BROWNS FERRY NUCLEAR PLANT, UNIT 1

AMENDMENT TO FACILITY OPERATING LICENSE

Amendment No. 216
License No. DPR-33

ATTACHMENT TO LICENSE AMENDMENT NO. 216

Figure 2.1-1

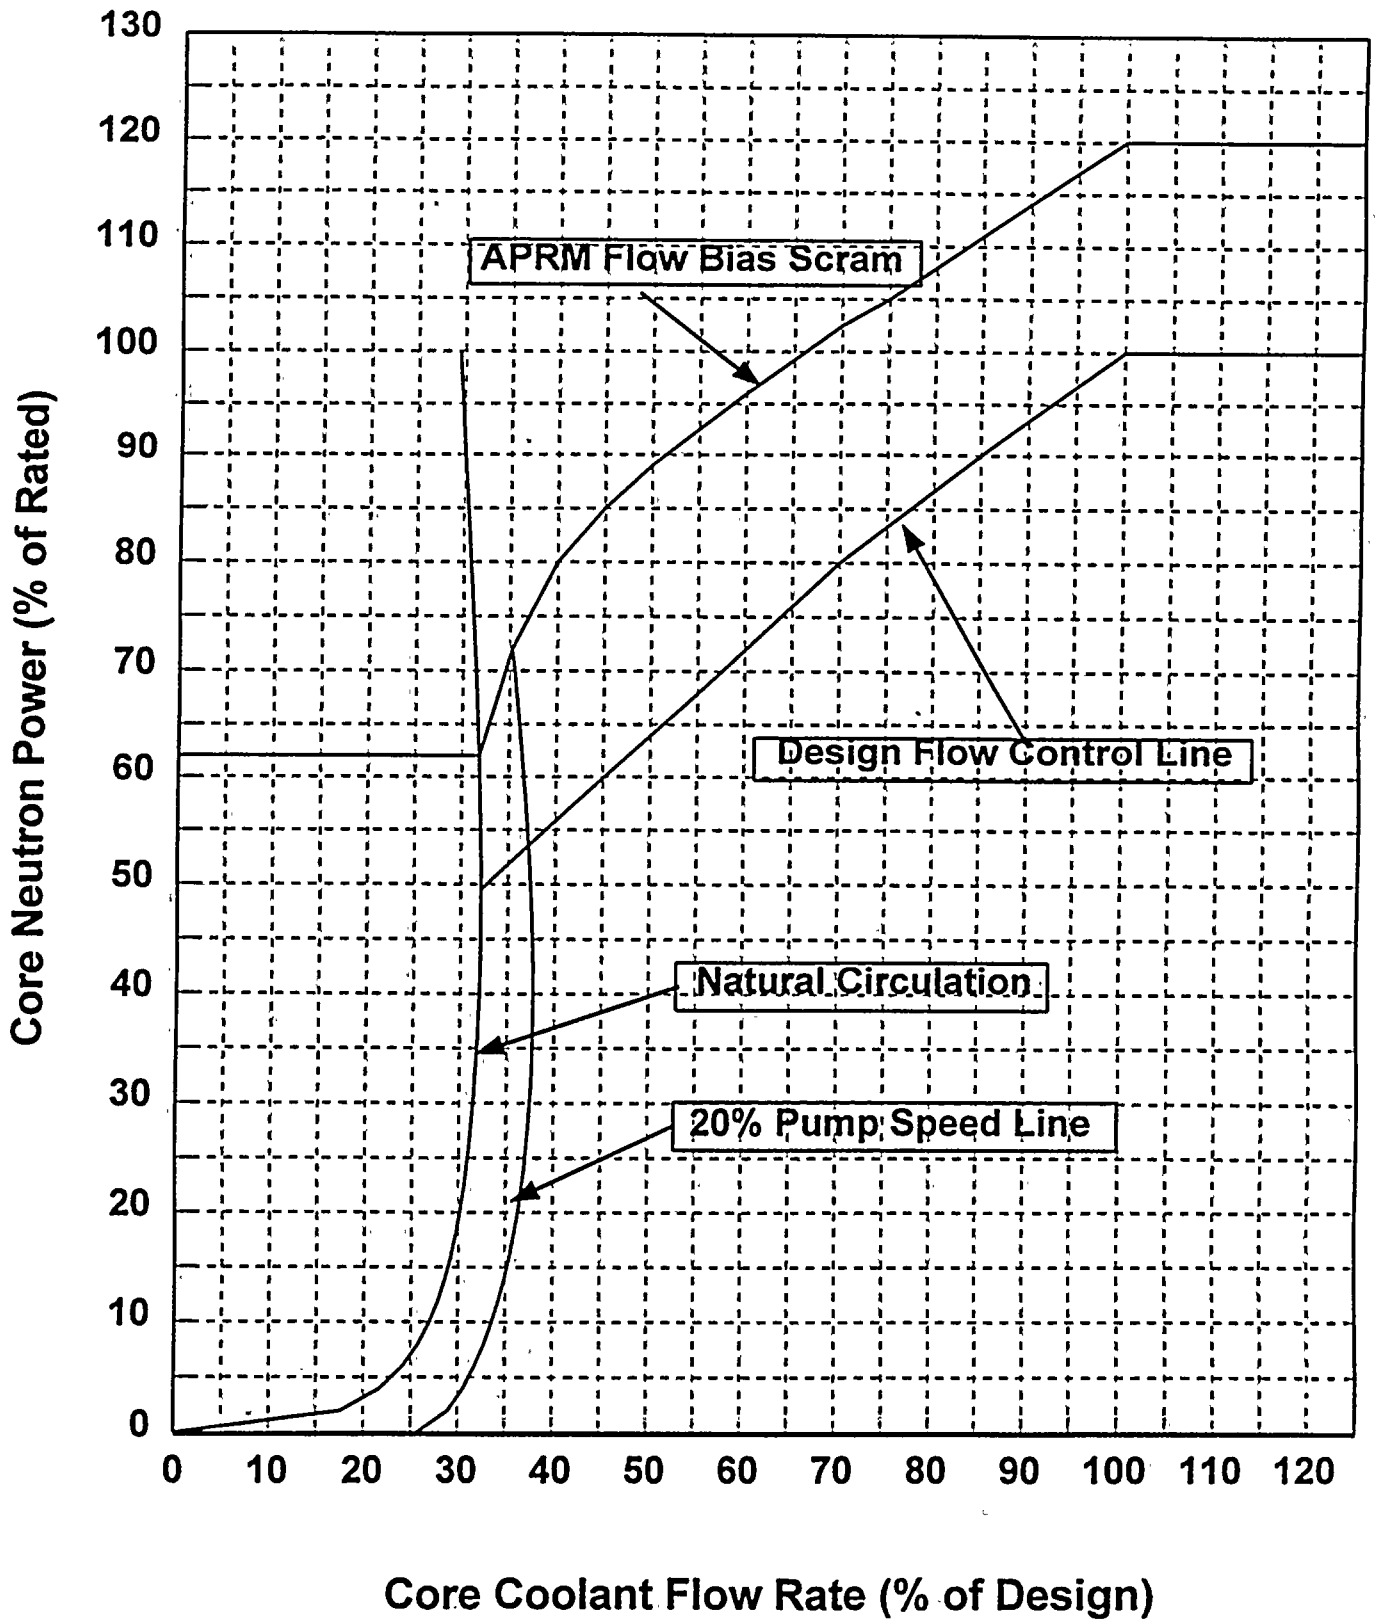
DELETED

Figure 2.1-1

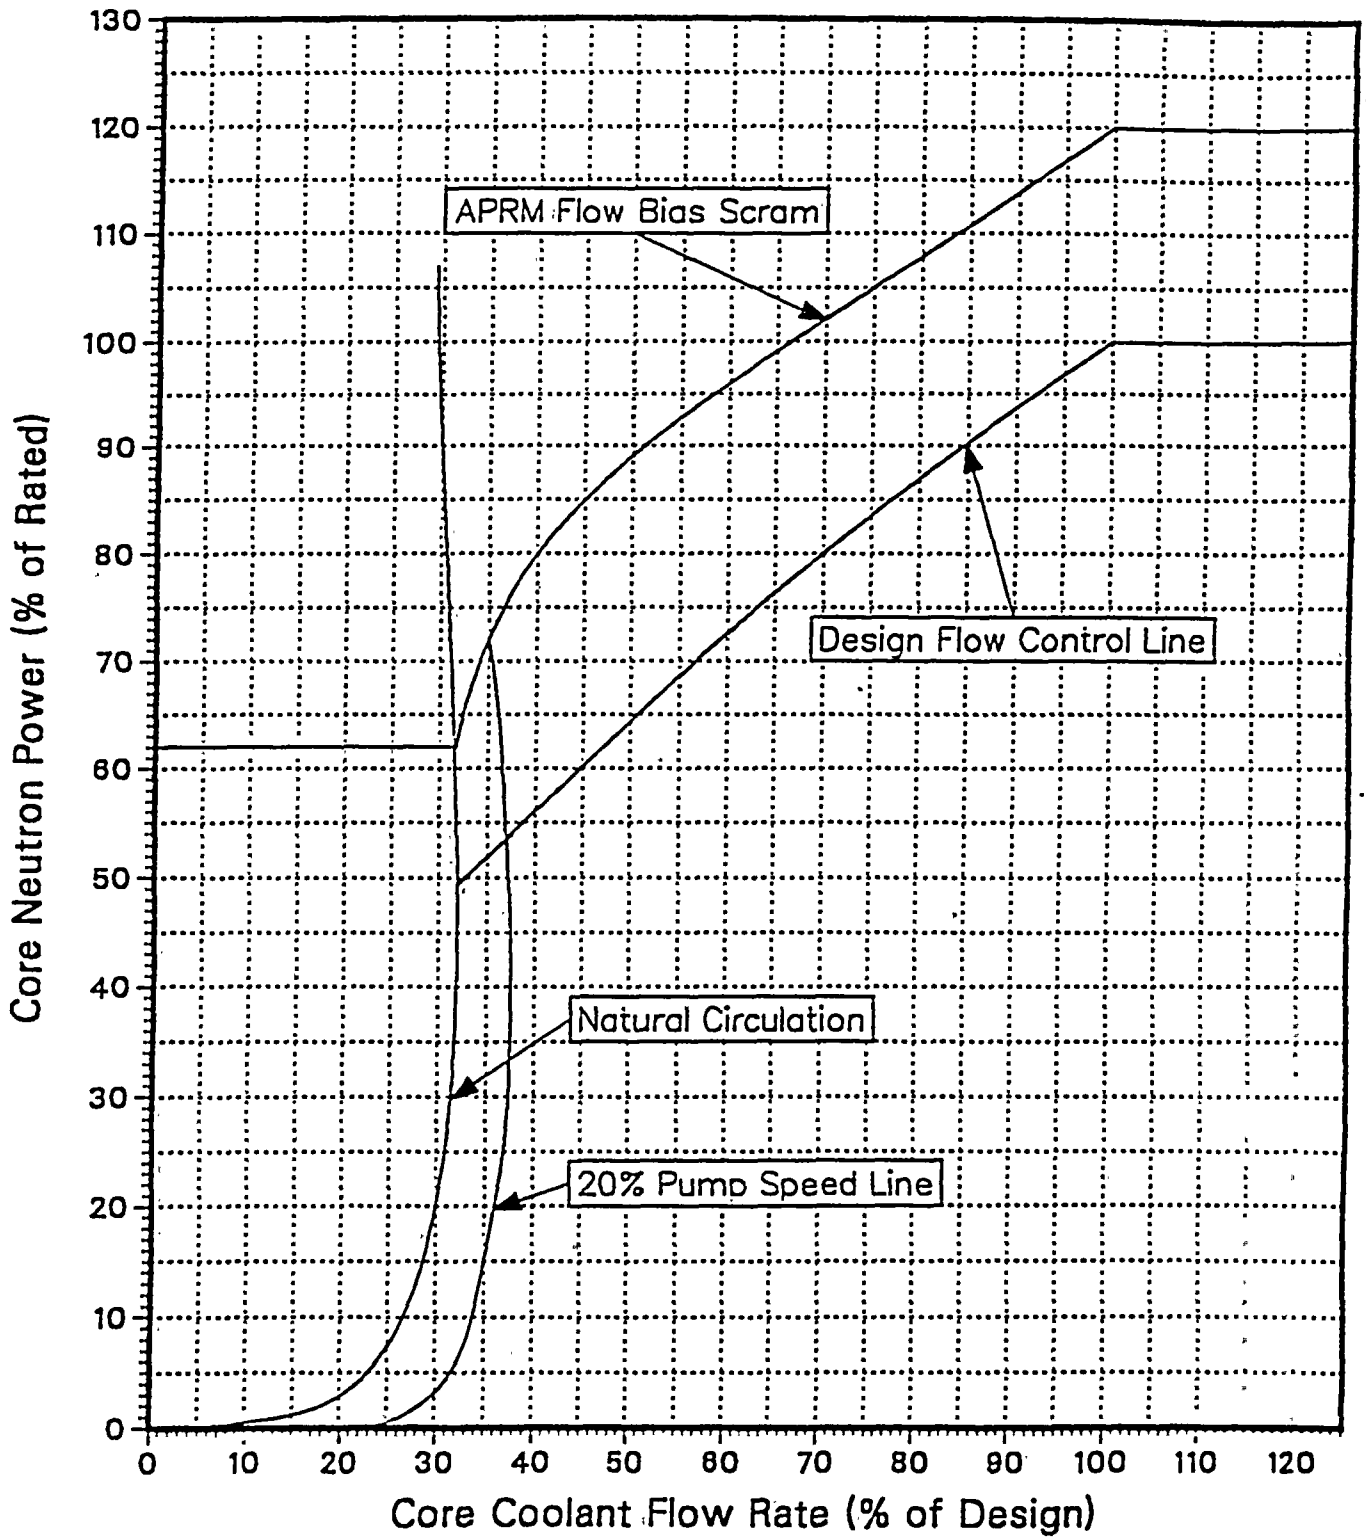
DELETED

Figure 2.1-1

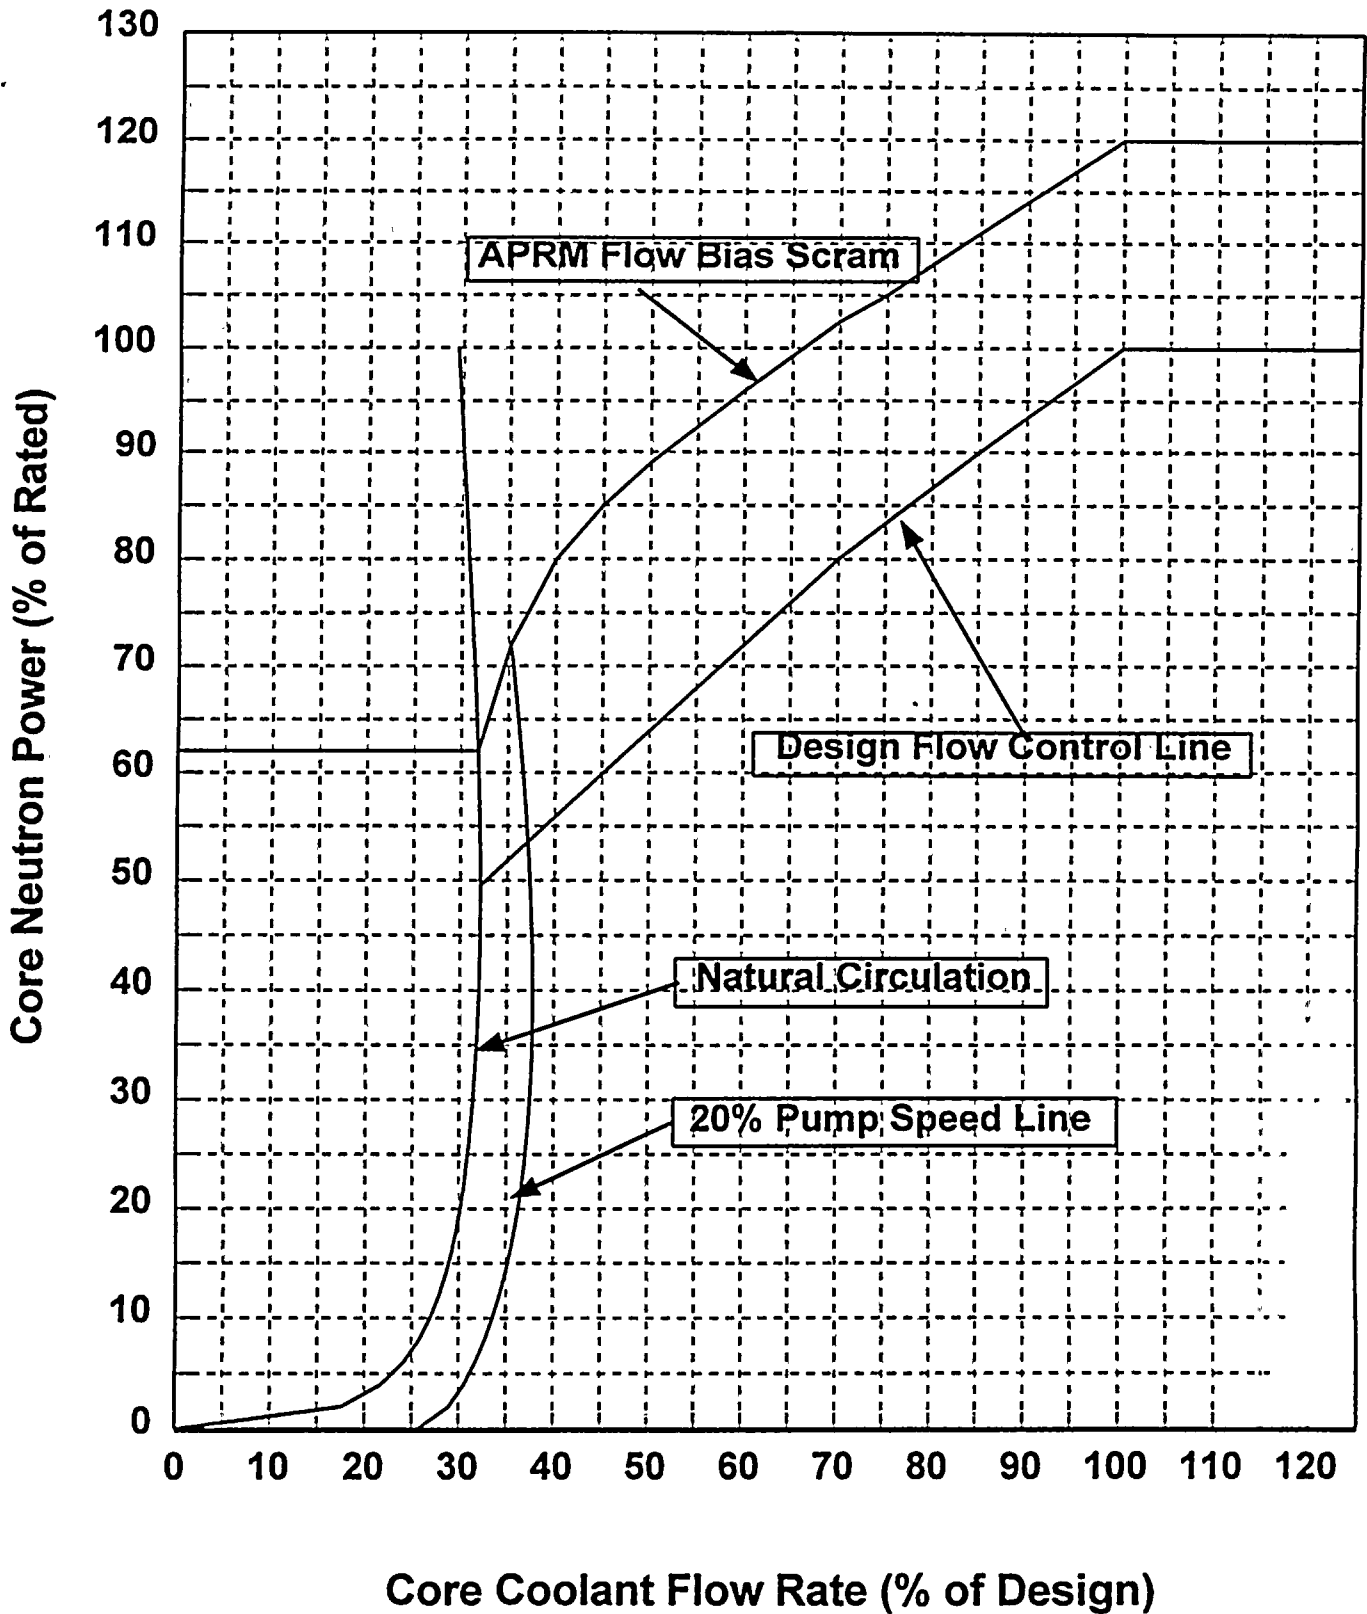
DELETED
